1978 Corvette: Service Bulletin: Air Conditioning Compressor Noise

Model and Year: 1978 Corvette with RPO L48 Engine and M38

Bulletin No: 78-T-76

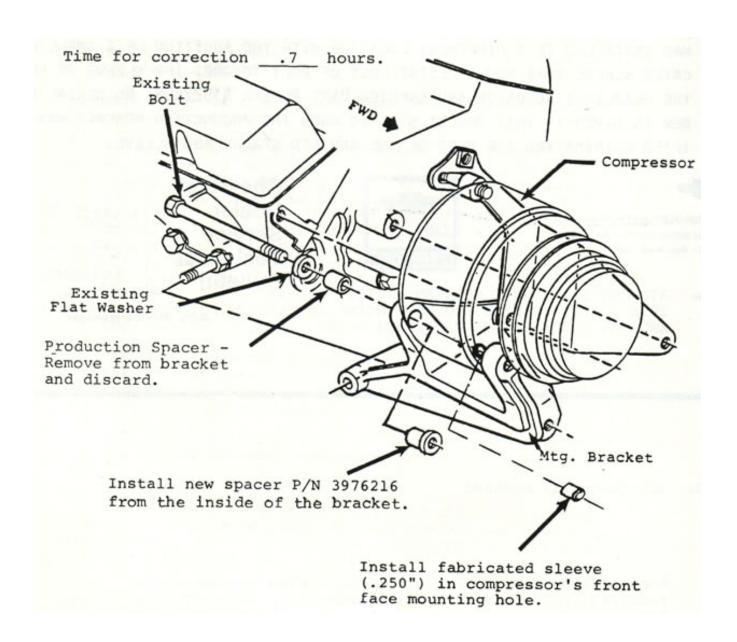
Some 1978 Corvettes with air conditioning may exhibit a rumbling type noise most noticeable at or just off idle RPM, with the air conditioning on, and the transmission in drive.

This condition usually occurs under high ambient temperatures and high head pressured and is caused by a reduction of compressor mounting bolt torque which results in compressor "wobble" and subsequent abnormal deflection of the compressor belt.

In production, the compressor mounting has been revised for 1979 Corvettes. Complaint vehicles can be corrected by using a new mounting bracket spacer, P/N 3976216, and the addition of a sleeve fabricated from a Corvette headlamp actuator sleeve, P/N 3922498, as outlined on page 2.

1. Obtain P/N 3976216 spacer and P/N 3922498 sleeve from stock.

- 2. Cut the P/N 3922498 plastic sleeve in half, resulting in two .250" long sleeves of which one will be used.
- 3. Remove the compressor belt and disassemble the compressor from the mounting brackets.
- 4. Lift compressor from bracket to allow access to both the original spacer in the mounting bracket hole and the mounting hole in the front face of the compressor where the feed-through bolt will exit.
- 5. Remove original spacer and install new spacer, P/N 3976216 in its place and the fabricated sleeve (.250") in the compressor face mounting hole as shown in Figure 1.
- 6. Reinstall compressor and belt.
- 7. Finalize the repair by tightening the compressor belt to 100 +/- 5 lbs. and torquing the compressor mounting bolts to 30 ft. lbs.
